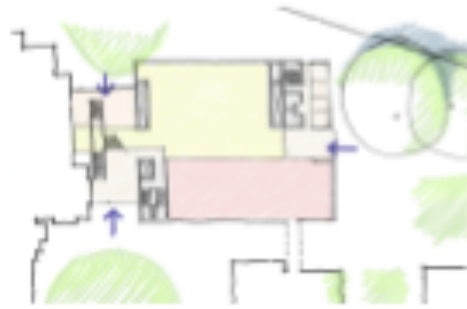
Bruce said that a much smaller Animal Facility would be disastrous to functionality, and would limit UO’s ability to recruit mouse geneticists. The basement location is not desirable but could be considered; the connections to the first floor would have to be very effective.
